**RE: SUBMISSION TO THE REVISED WONTHAGGI NORTH EAST PRECINCT STRUCTURE PLAN, DEVELOPMENT CONTRIBUTIONS PLAN, ASSOCIATED DOCUMENTS & BACKGROUND REPORTS
PROPERTY ID #46 & 47 – KORUMBURRA – WONTHAGGI ROAD ST. CLAIR**

**RE: SUBMISSION TO THE DRAFT WONTHAGGI NORTH-EAST PRECINCT STRUCTURE PLAN
PROPERTY ID #46 & 47 – KORUMBURRA – WONTHAGGI ROAD ST. CLAIR**

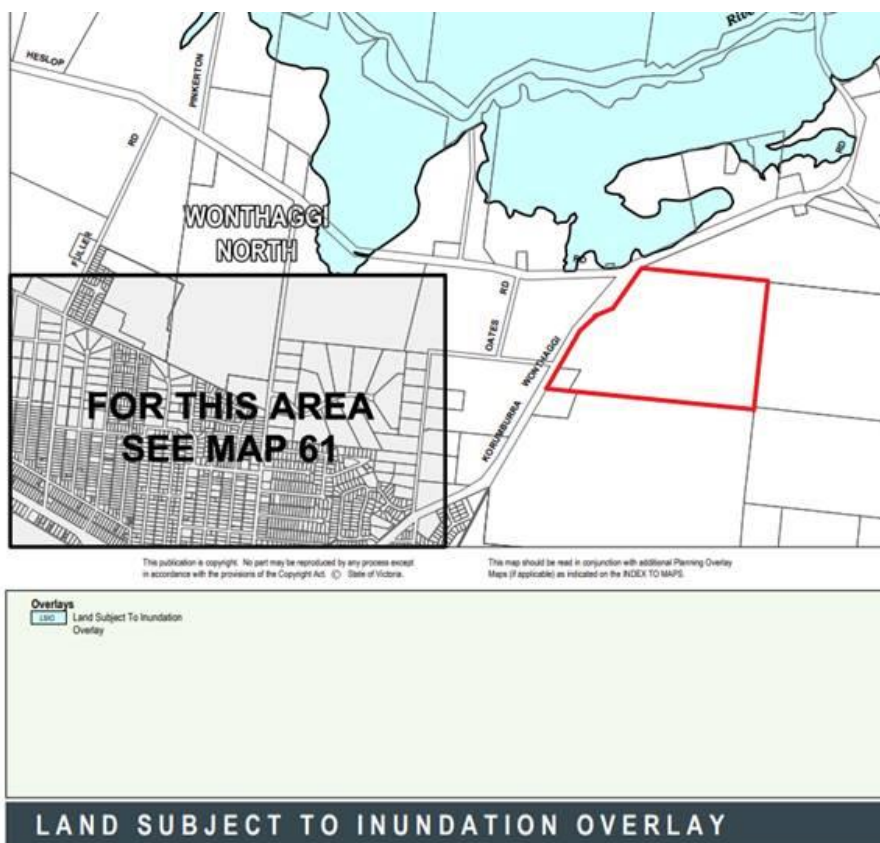
- We reserve the right to provide a response on the design and cost of intersection IN-04, which has been relocated further south than previously proposed, once provided.

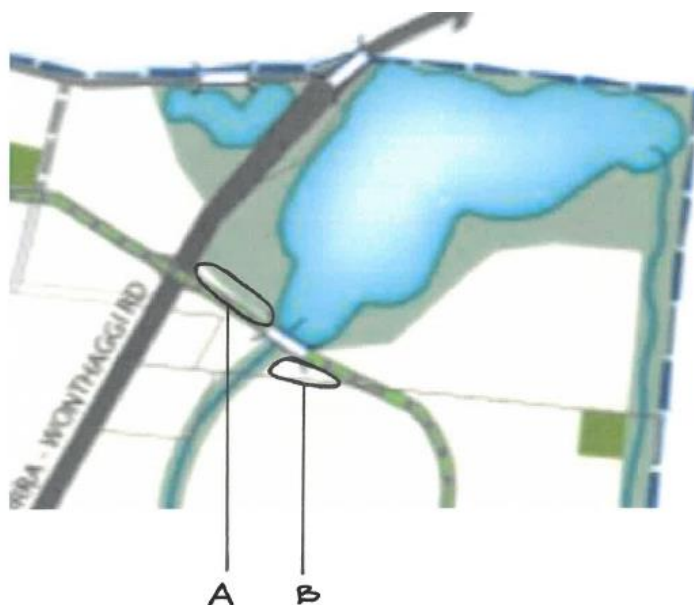
- Plan 11 of the PSP shows that the shape & size of WL-01 have changed substantially to what was previously proposed and what is shown in the updated Engeny Drainage Strategy. The screenshot below from Page 69 of the Alluvium Functional Design Report shows the proposed footprint of WL-01 in the Engeny Drainage Report (dashed blue line) over the Alluvium functional design for WL-01.

- The report prepared by Alluvium states that the land within the inundation extent falls within the LSIO.
- As can be seen on the excerpt from Map 57 from the Bass Coast Planning Scheme below the land (outlined red) does not lie within the LSIO.
